Re: Planned Development for pickle processing facility at 1101 W. Debbie Lane, Mansfield, Texas

Existing conditions at Dalton Best Maid property

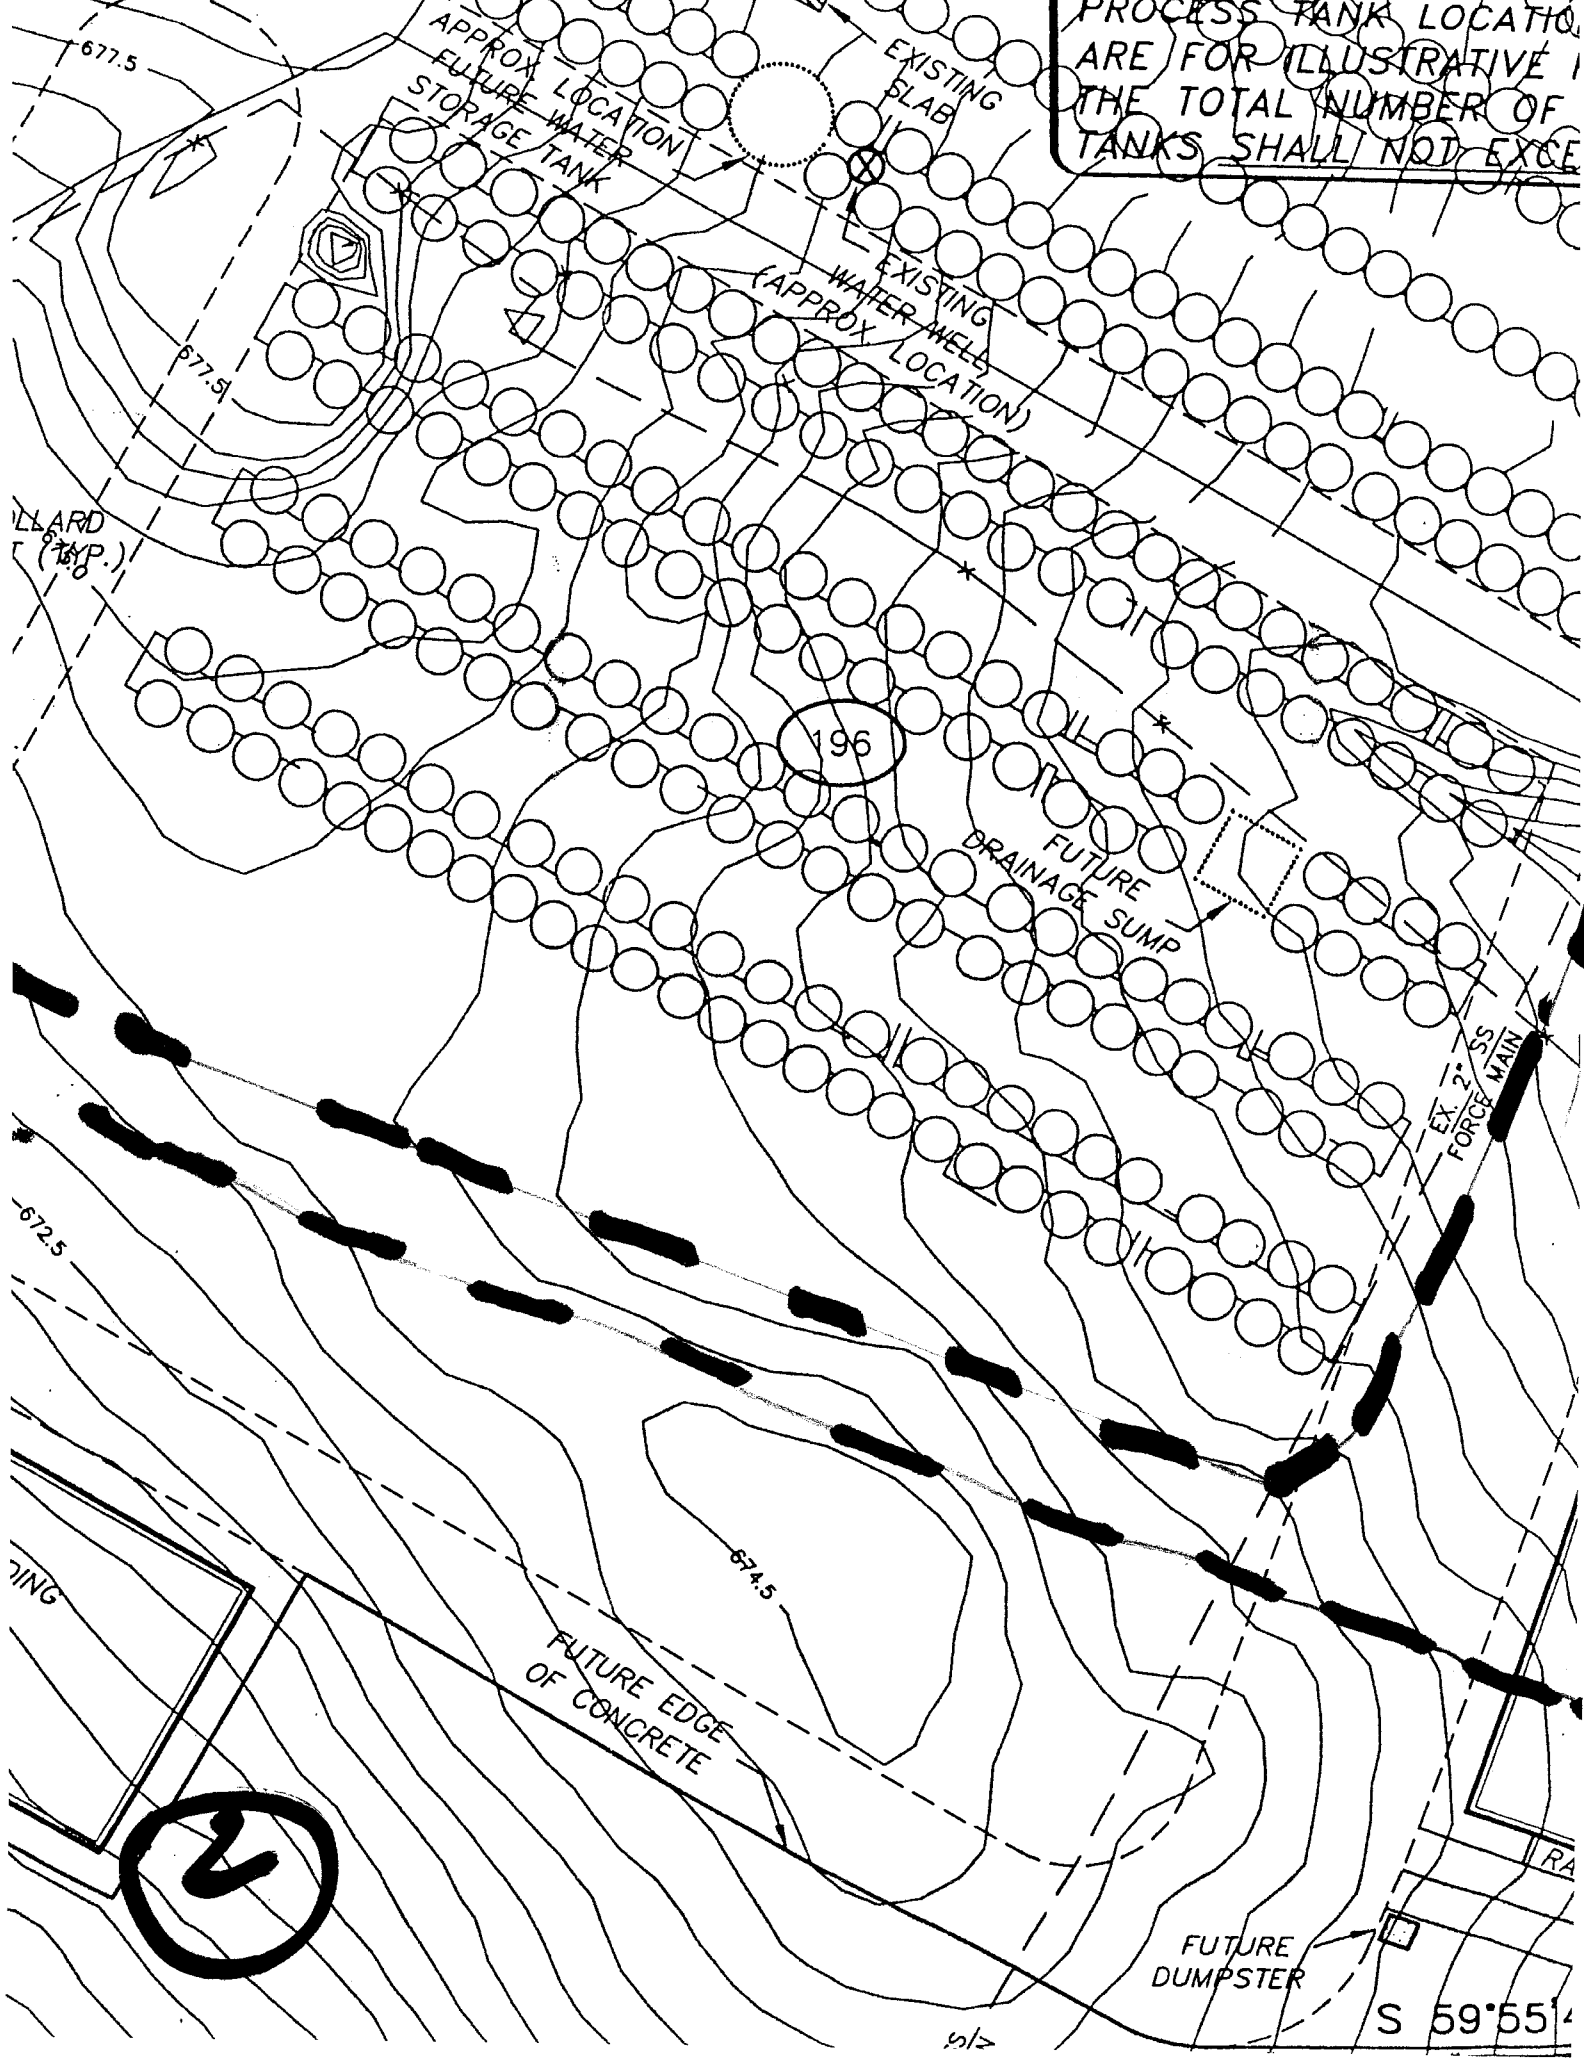
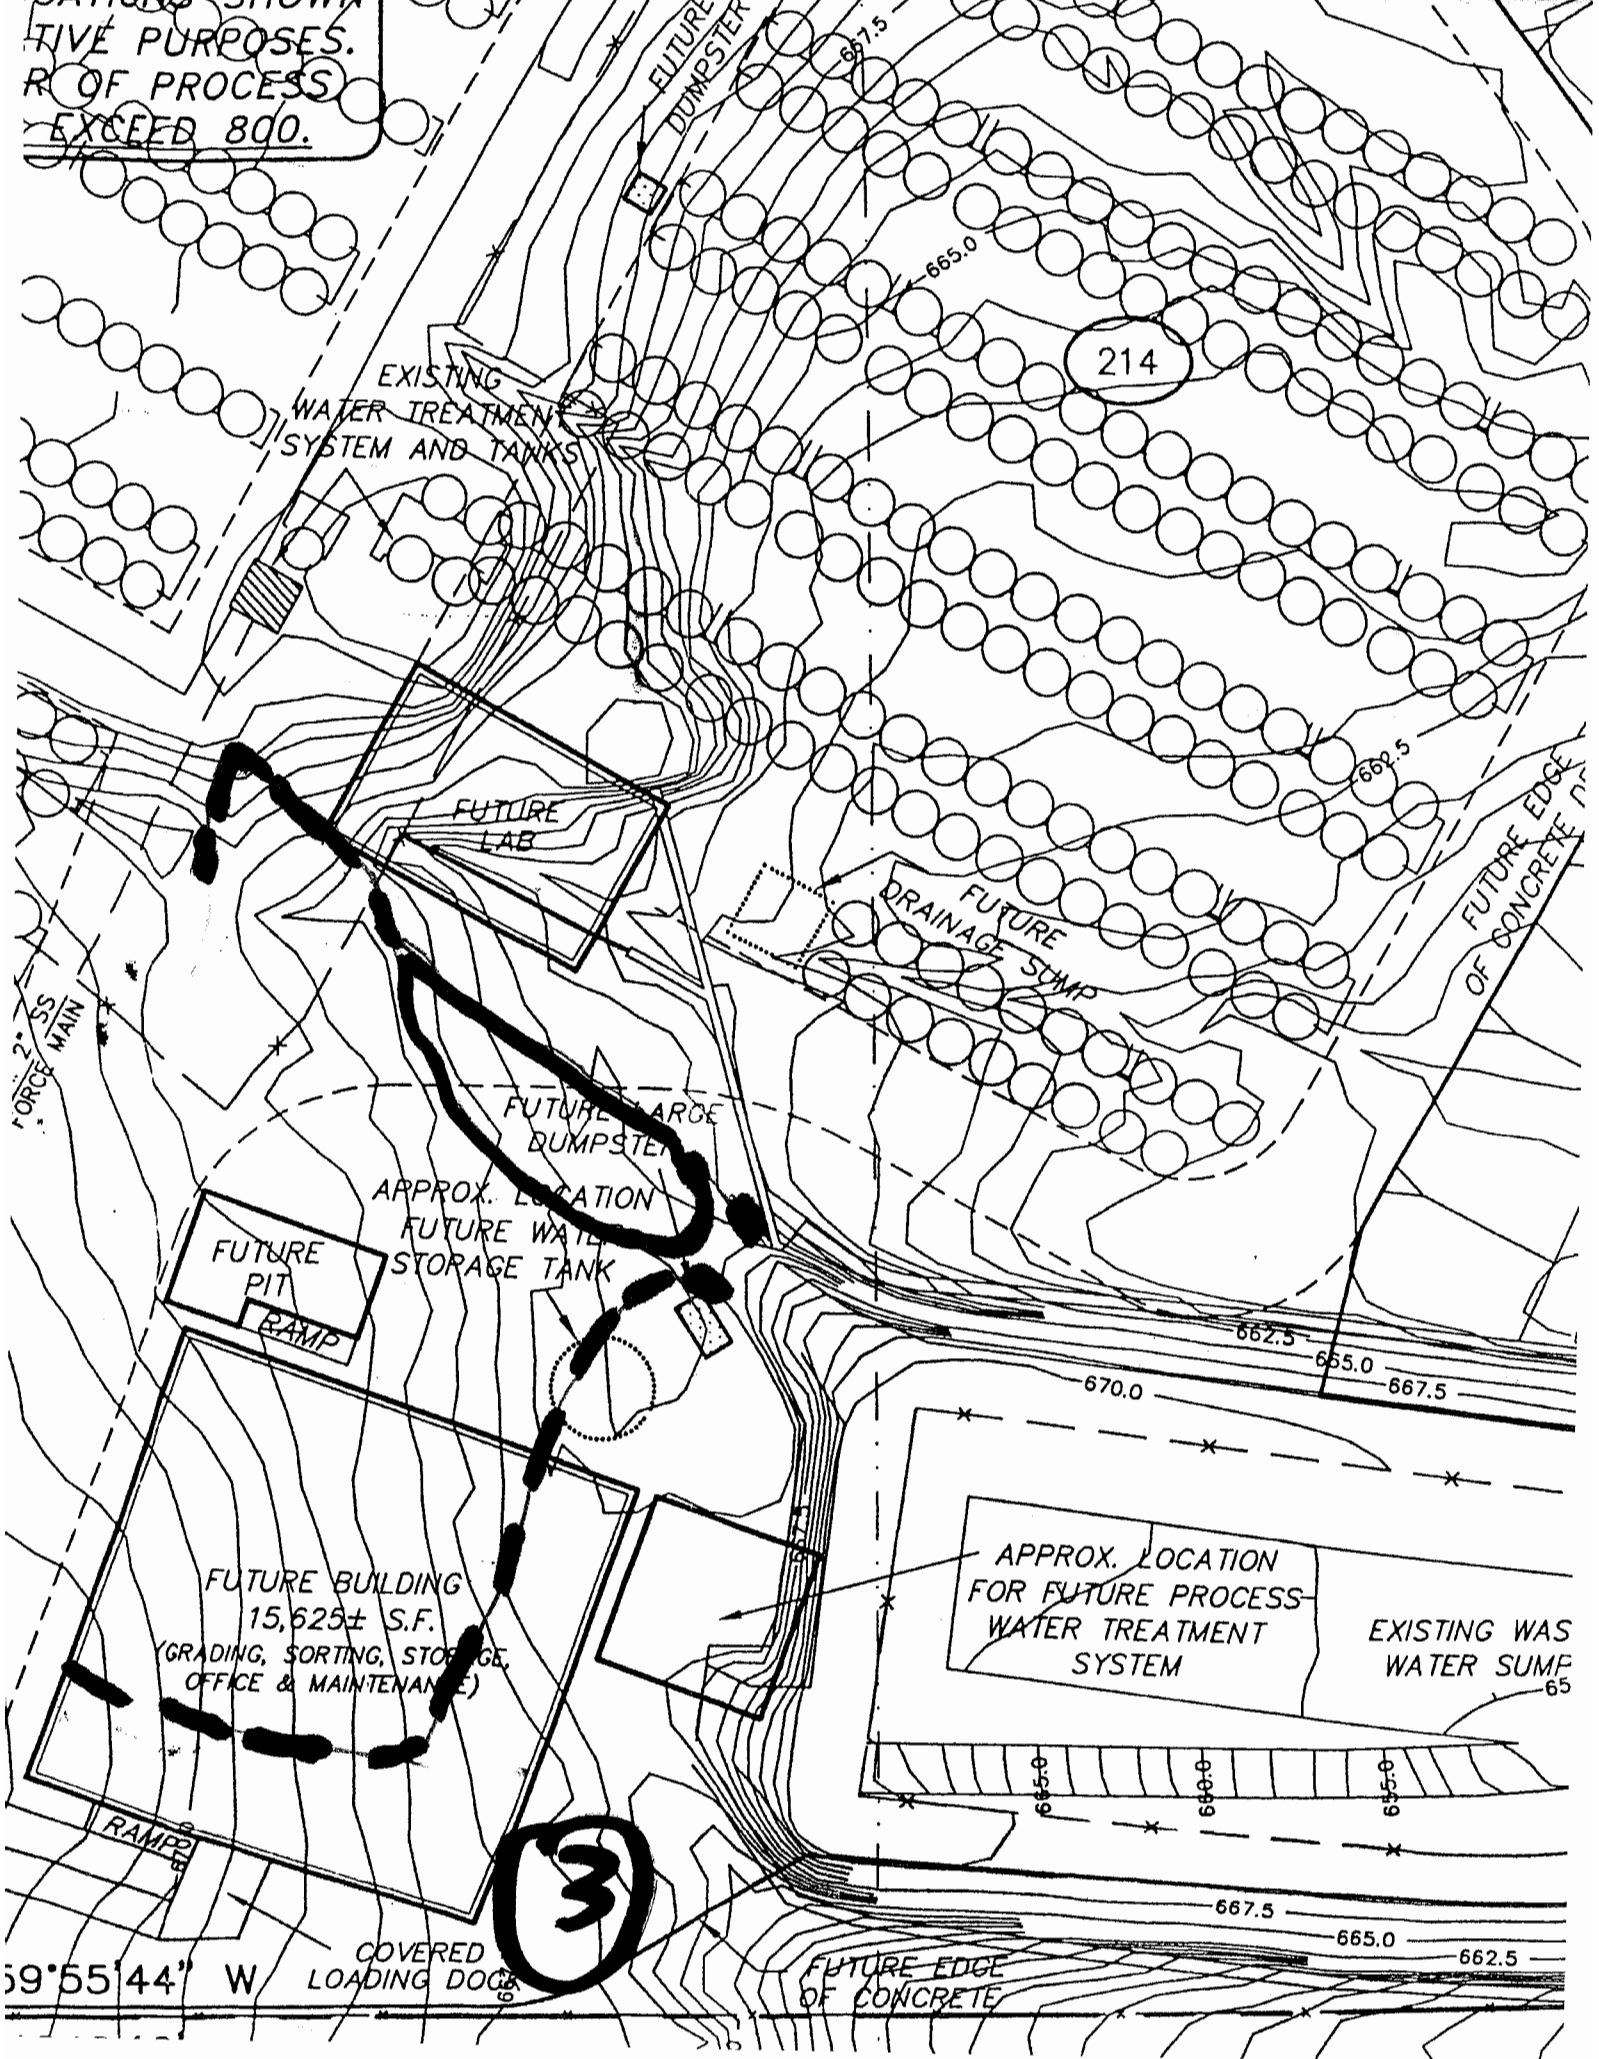
4. We believe there is some confusion regarding the driveway south of the tanks leading to the waste water sump tank and the gravel area in front of the waste water sump tank. As you know, the PD site plan that was approved was a long-term, forward looking plan. The actual caliche driveway in existence on the property at the present time is not a permanent driveway, but rather, is a seasonal/temporary drive off the driveway that has been in existence for many years prior to 1996. This seasonal/temporary driveway cuts across an area on the site plan that is designated in the future for a building, truck scale and truck/trailer storage. It is utilized during the harvest period by the incoming growers' trucks to bring the cucumbers onto the facility for disposition and processing, rather than having the trucks lined up along North Main Street. Since this site plan contemplates the long term development of this facility,

we request that a note be added to the site plan permitting this seasonal/ temporary driveway to remain until construction is completed in the future of the buildings indicated on the southern and eastern parts of the property. At that time the contemplated future driveway will be constructed and this seasonal/temporary drive will be eliminated. I have enclosed exhibits that I have, as best I can, traced the location of this seasonal/temporary drive on the PD site plan.

Likewise, the area in front of the waste water sump tank is constructed of gravel, rather than concrete, because it is planned to be the site of a future building of 15,625 +/- square feet. If this were to be concreted, then to construct the building in the future such concrete would have to be demolished and removed so that infrastructure for the building could be put in place and a new foundation poured. Again, we request that a note be added allowing this gravel area to remain until construction commences on the future building.
